**Municipal Services Center, Council Chamber
3600 Tremont Road**

Subject: 4190 Greensview Drive (#26-1672) - Informal review of a proposed home gym that exceeds maximum height and setback requirements for detached habitable spaces.

Subject: 2471 Westmont Boulevard (#26-1658) - Update to the Board on a preliminary concept for a three-story mixed-use building.

Subject: 2082 Fontenay Place (OR-xx-26, VAR-24-26) — Review of a plat amendment and variance to permit the retention of swimming pool decking and a patio that was installed without a permit and is located within the rear yard, which is prohibited.

South Elevation
3/32" = 1'-0"

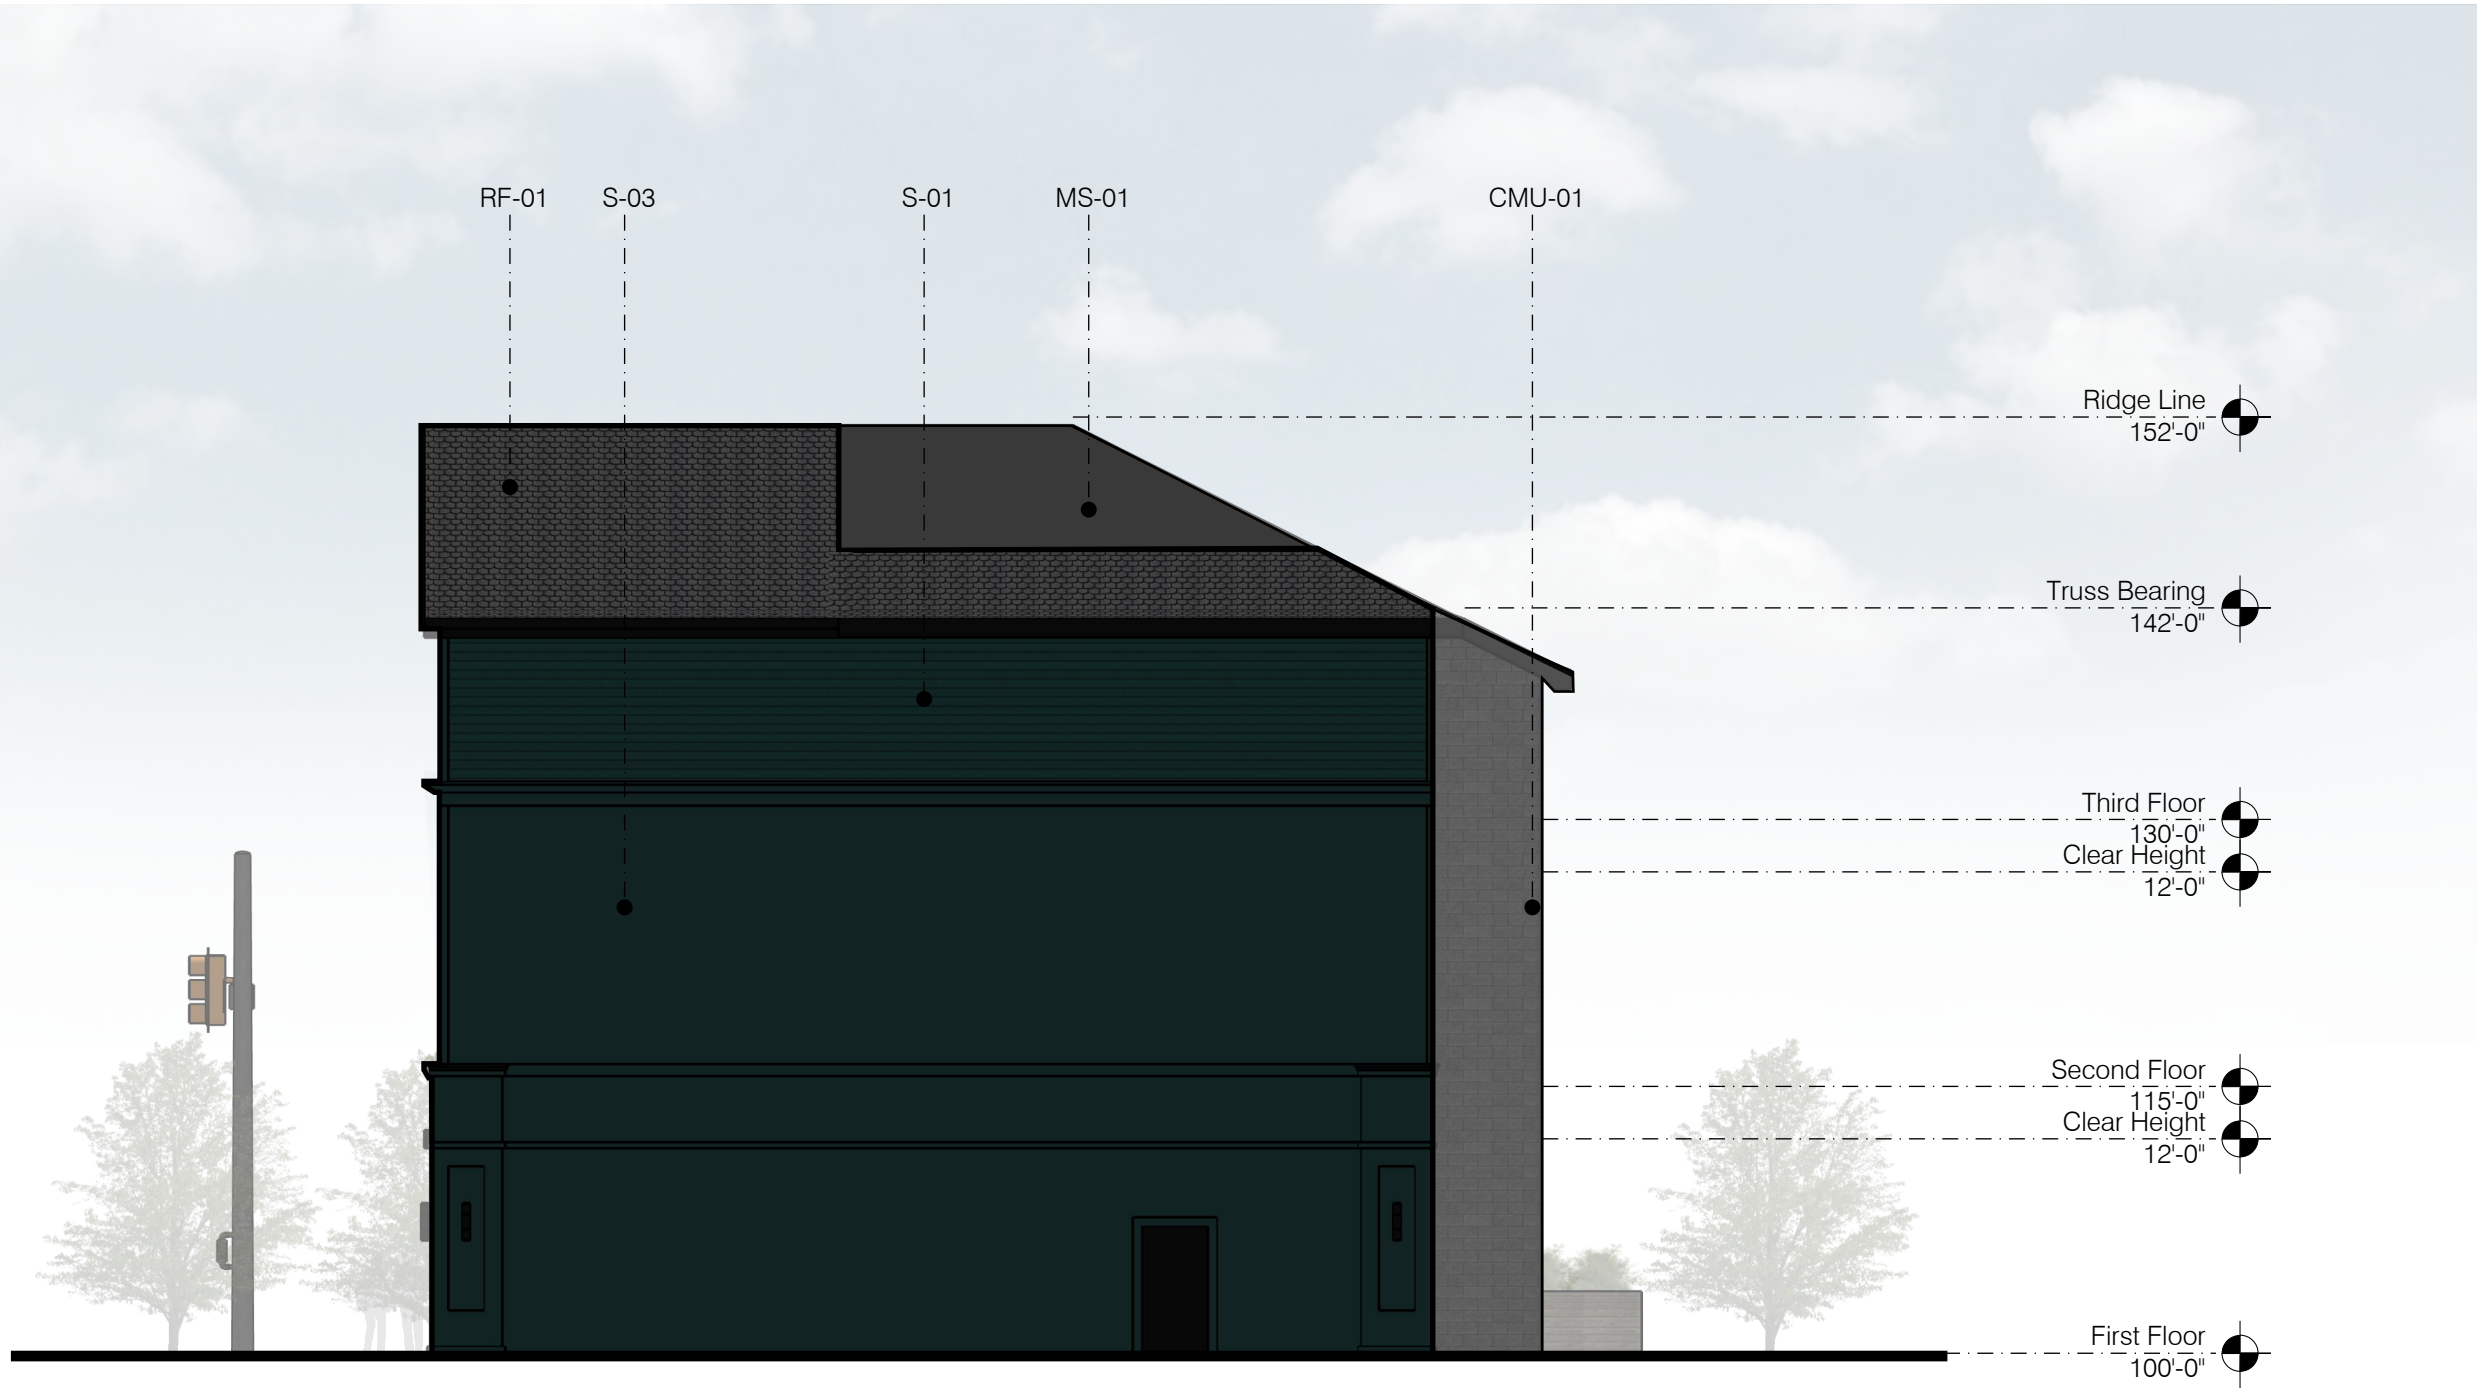
- Further development of the proposed exterior, which includes red brick on the front section of the building and lap/shake siding on the rear and upper section of the building. The third floor includes a pitched roof and trellis along Westmont Boulevard. Inspirational imagery was also provided, showing where some of the design thought came from. *[Staff would like the Board to review the third floor design and would recommend that the applicant continue the north elevation material treatment to the west elevation in lieu of the proposed CMU.]*

A Mortgage Location Survey prepared for and certified to:

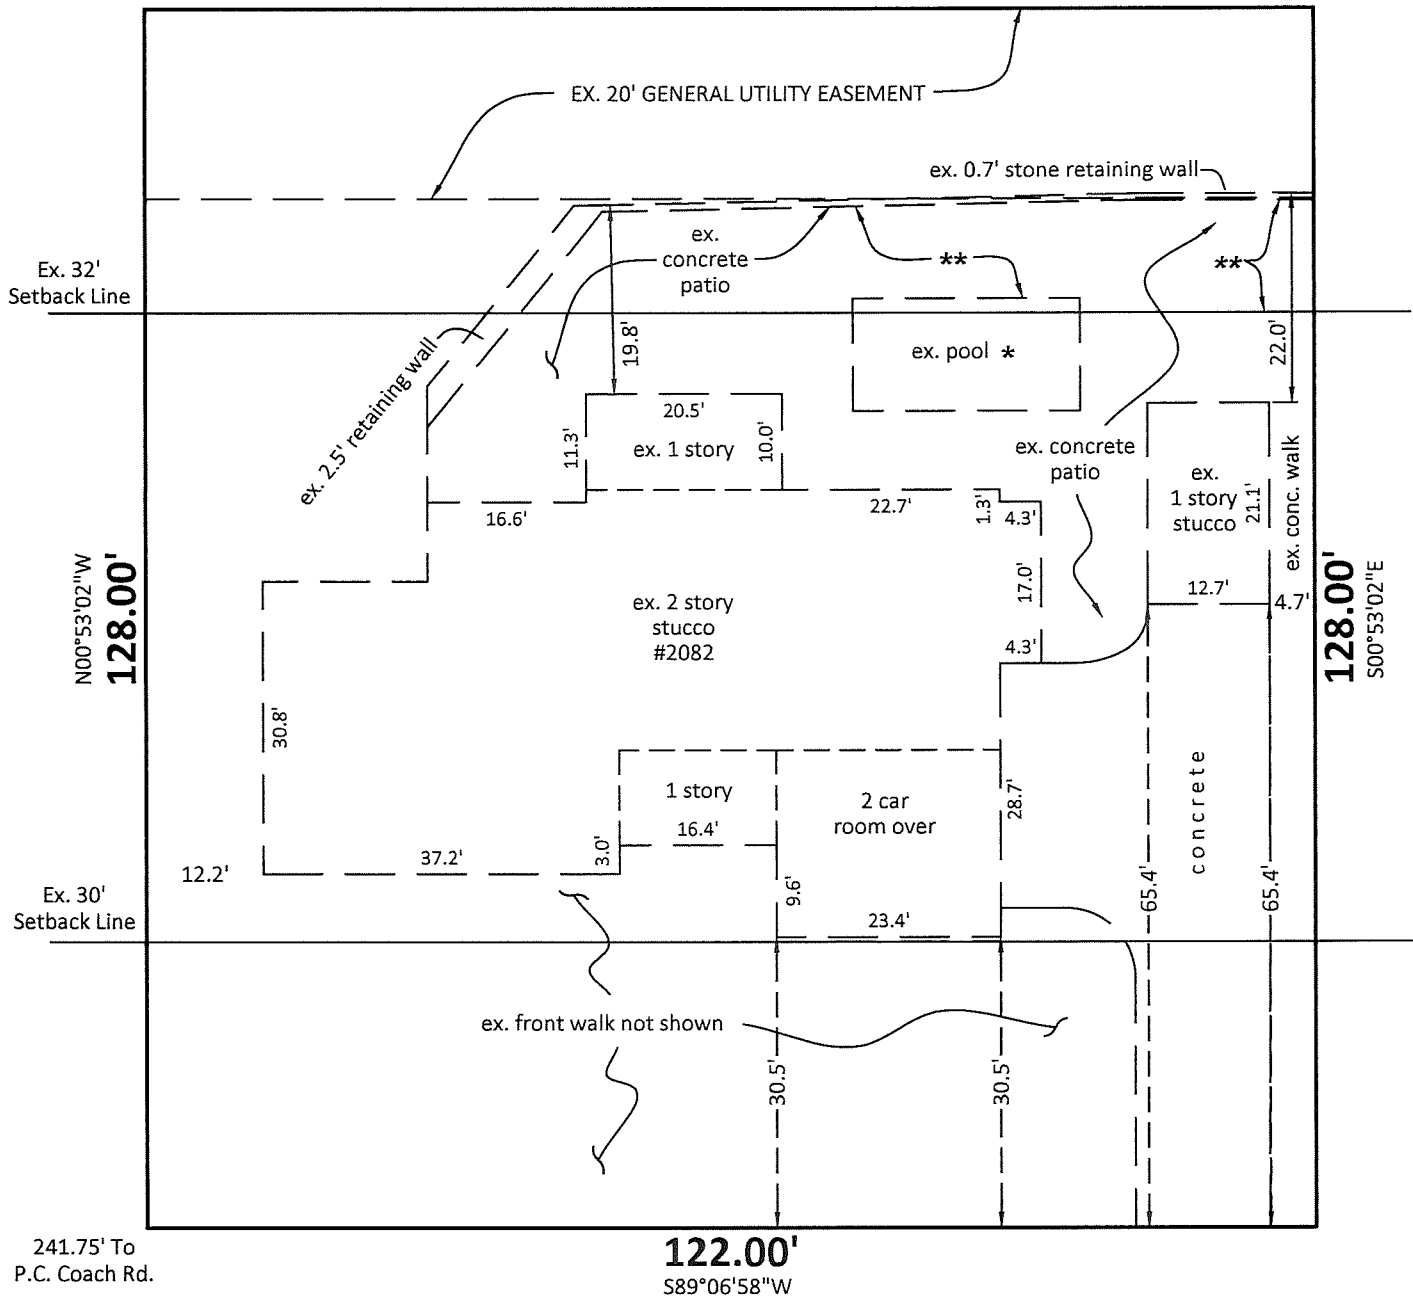
- Amends the 32-foot platted rear yard setback to 19.5 feet to permit the retention of the existing swimming pool and associated patio/decking.
- Requests variances to retain the improvements that were made without a permit and allow an increase to the total development cover maximum from 45% to 50%.

* = Ex. pool - "Phase 1" Permit Improvement approved by City - ± 1.5' over setback line

** = Ex. concrete patio - "Phase 2" No Permit - 12.5'± over setback line
